Re: 2nd Technical Submission Review – The Overlook at Sorrel Ranch – Preliminary Plat and Final Plat

Application Number: **DA-1379-26**

Case Number: **2019-4017-00; 2019-3050-00**

OVERLOOK AT SORREL RANCH SITE PLAN WITH ADJUSTMENTS

C-1

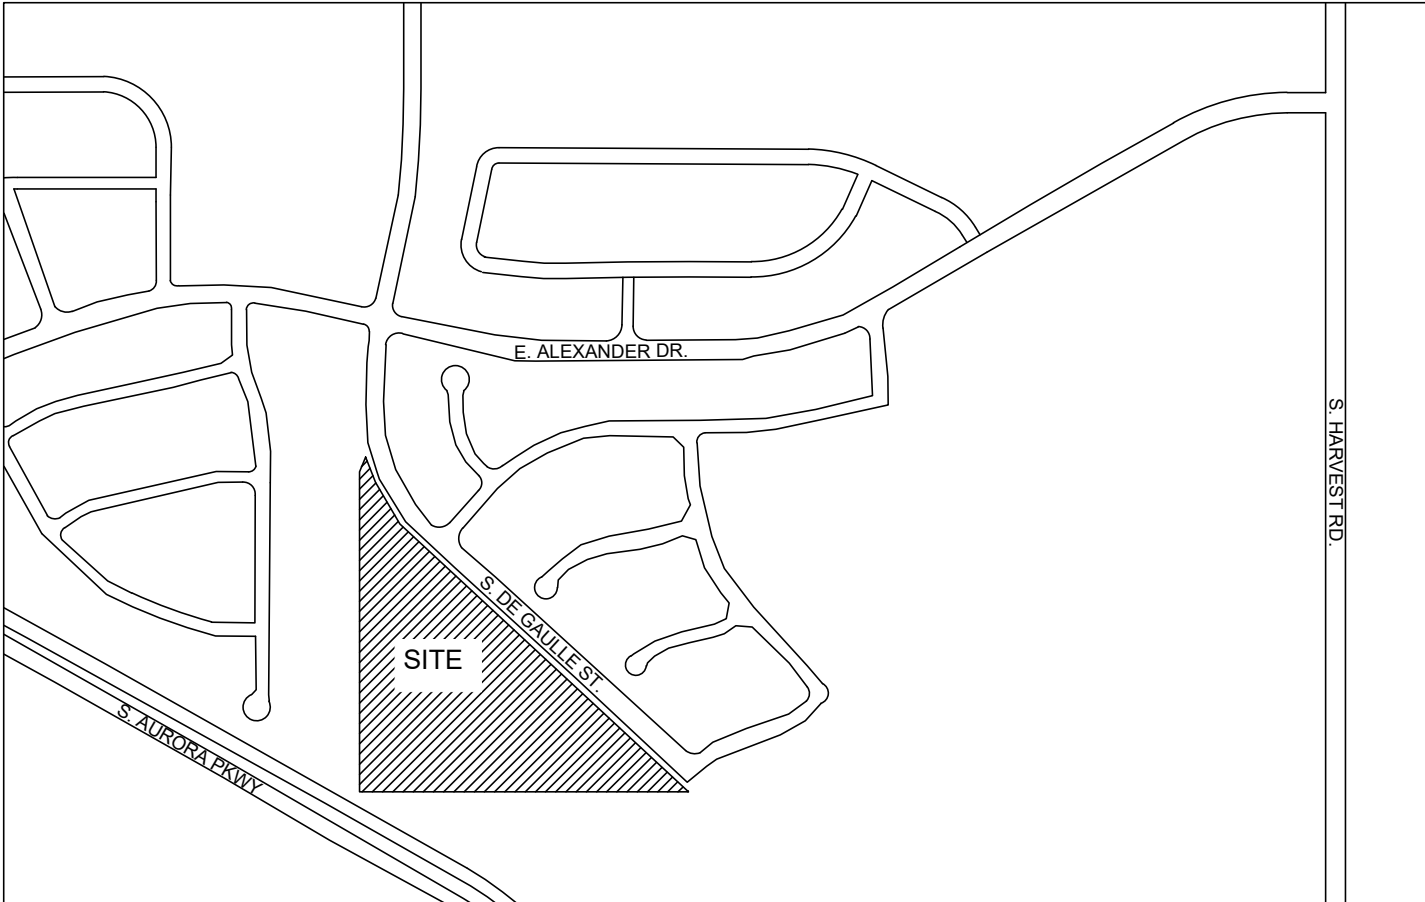
3A. NOTE: file name locations are okay for review, but must be removed prior to printing final mylars. *Removed*

3B. Change "waiver" to "adjustment" in the Minor Adjustments block. *Changed*

File name locations are okay for review, but must be removed prior to printing final mylars

There are many printing errors throughout the plan. Please proof the planset prior to uploading the subsequent submission

Change waiver to adjustment

The site plan will not be approved by public works until the preliminary drainage letter/report is approved

Removed

Fixed

Changed

Noted

S-1

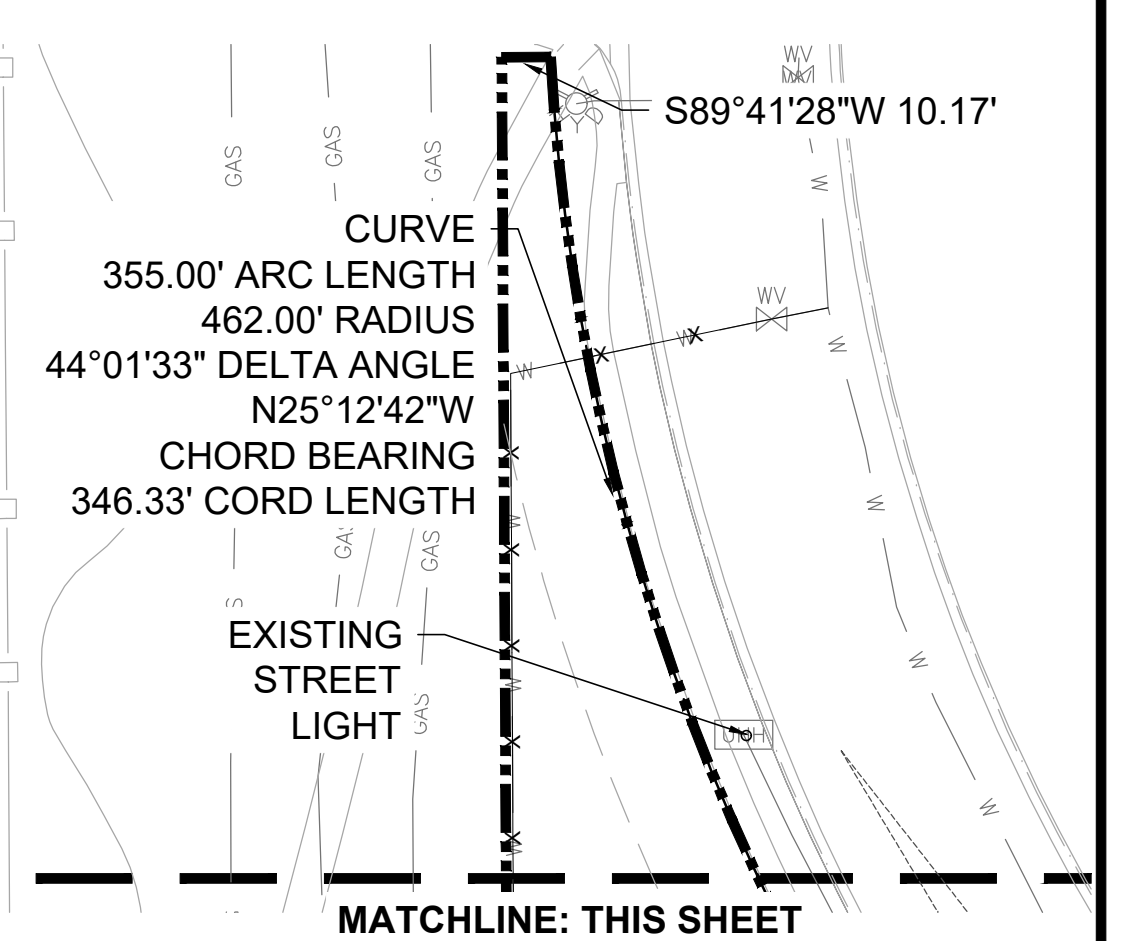
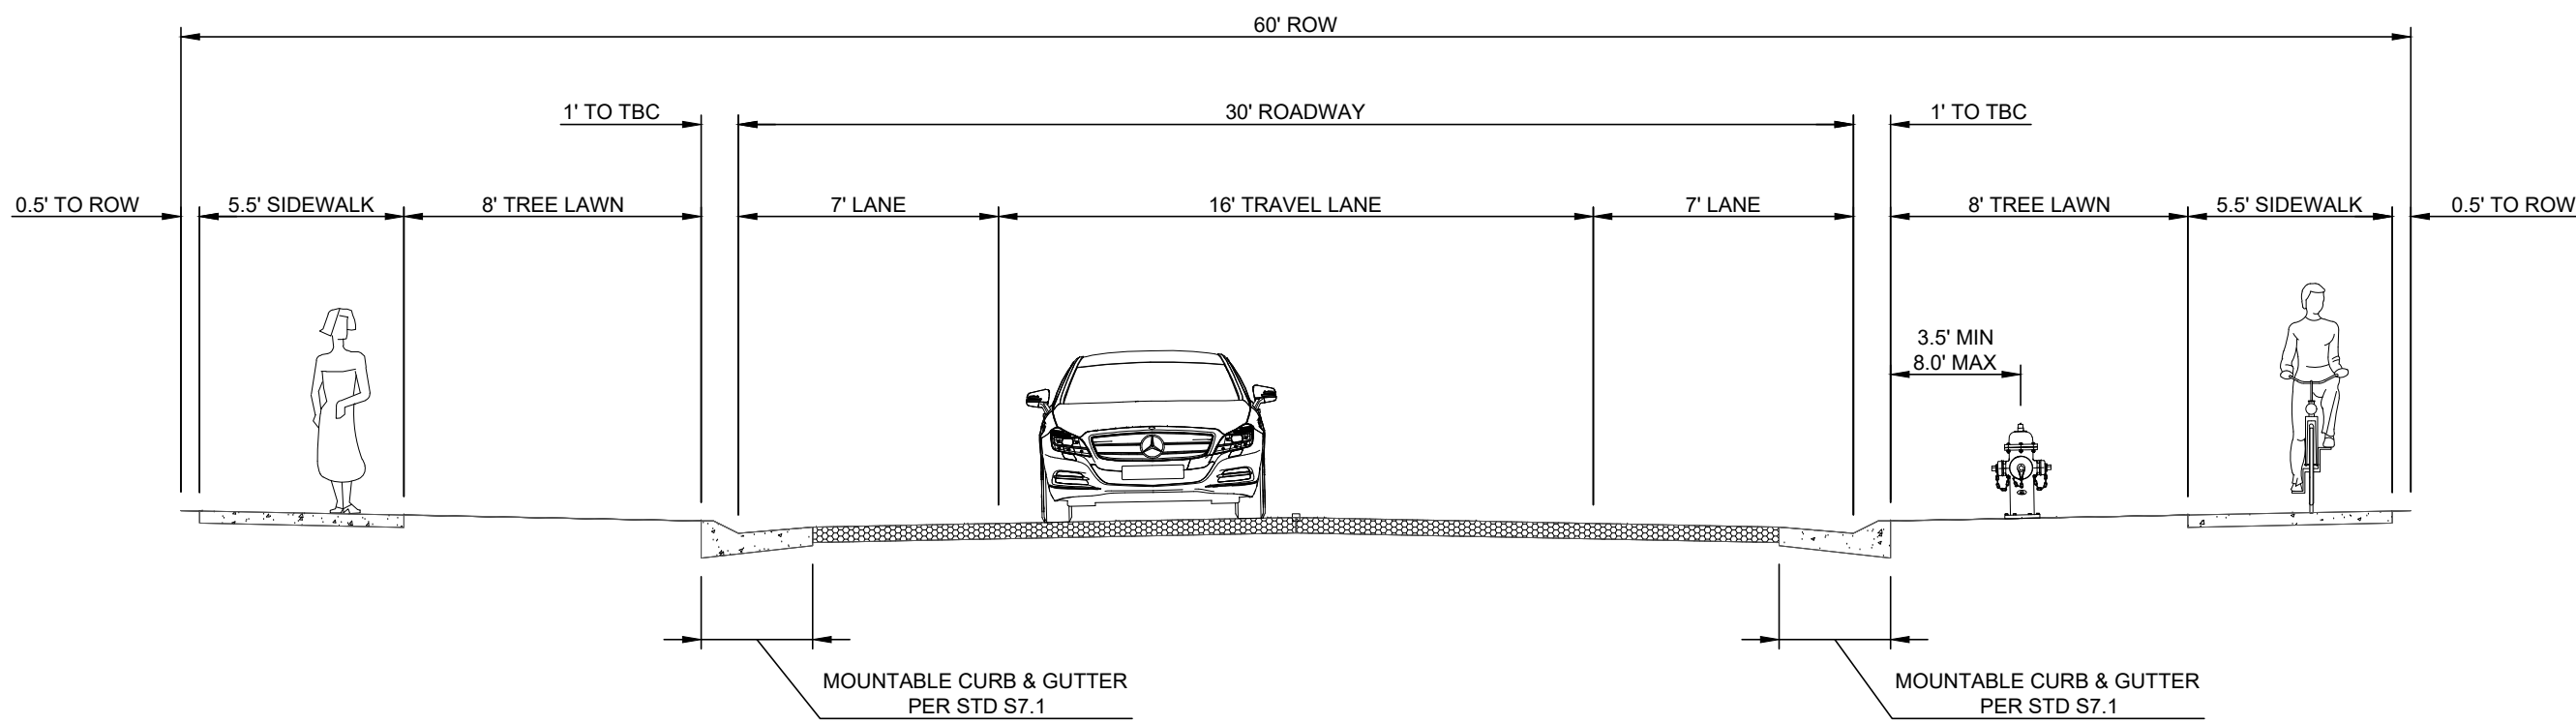
6B. A street light is required at the intersections shown on the redlines. *Street Lights Added*

6C. Retaining walls are not permitted to cross lot lines. For residential development, a maximum 48" wall height is permitted in rear lots. *A license agreement will be executed to cover the maintenance of the retaining walls across the lot lines. Retaining walls will be 48" maximum.*

SITE LIGHTING
N.T.S.

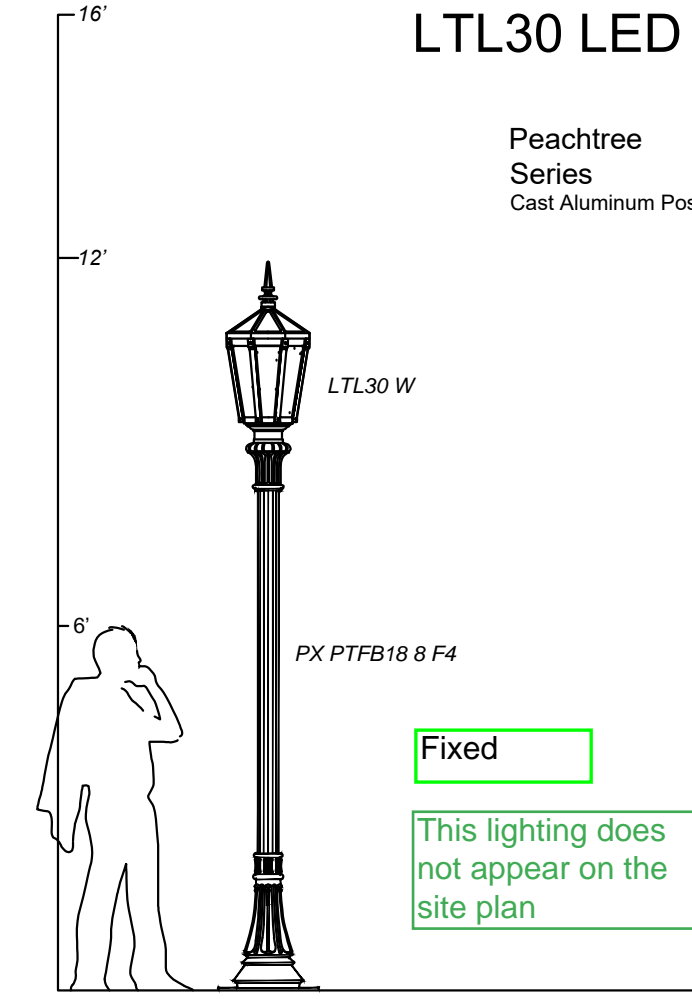
6E. The site lighting shown on this sheet does not appear on the Site Plan. *Removed from legend*

Added
And must meet
COA standards.

G-1

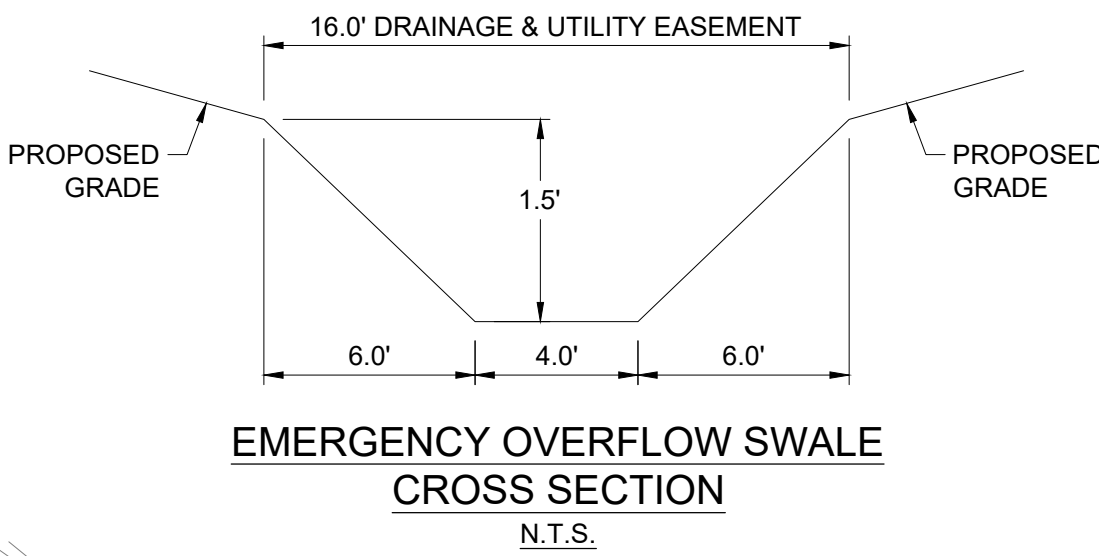
6F. Retaining walls are not permitted to cross lot lines. For residential development, a maximum 48" wall height is permitted in rear lots. *A license agreement will be executed to cover the maintenance of the retaining walls across the lot lines. Retaining walls will be 48" maximum.*

Lot lines, Tract Lines and
R.O.W. lines are to be
continuous lines - change
these lines

Retaining walls are
not permitted to
cross lot lines. For
residential
development, 48"
max wall height in
rear lots

Fixed

A license agreement will be
executed to cover the
maintenance of the retaining
walls across the lot lines.
Retaining walls will be 48"
maximum.

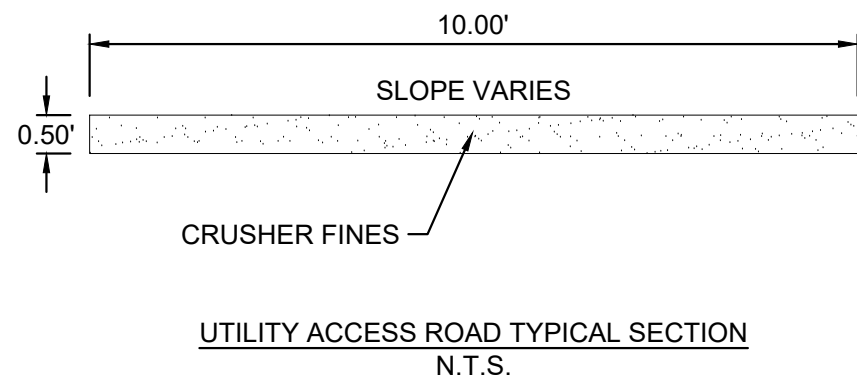
Lot lines, Tract Lines and
R.O.W. lines are to be
continuous lines - change
these lines

Fixed

License Agreement

A license agreement will be
executed to cover the
maintenance of the retaining
walls
